Access Compliance Report

Public Rights-of-Way

(Curb Ramps)

Intersection ID: 10336	Main Street: CALLAHAN_ST	Cross Street: POLK_ST	Location: S
ADA ID: EF2E45B78A38	Ramp Type: PerpDiag	Initial Pass/Fail: Pass	Overall Compliance: No
Codes/Mitigation Info/Possible Solution		Field Measurements/Component Compliance	
Severity Score: 27.5

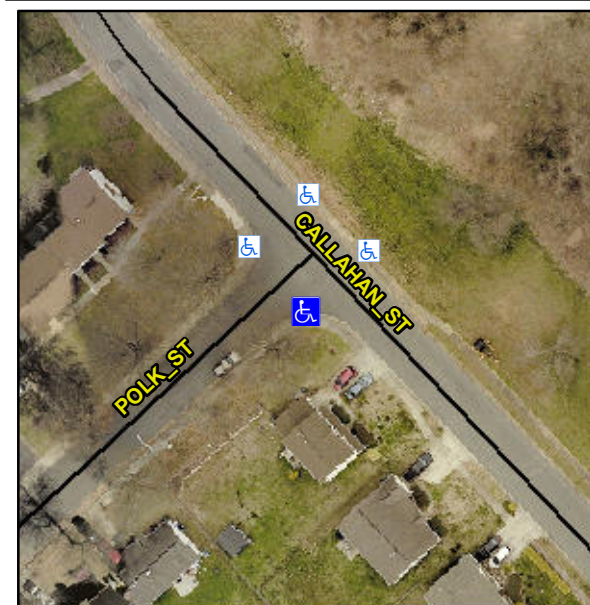
Not Found, R304.2.1, R304.2.2-Perp, R304.3.2-Para, R304.5.3, R305.1.4, R302.7, R302.7.2

Remove & Replace Curb Ramp With Two New Directional Ramps or Equivalent.
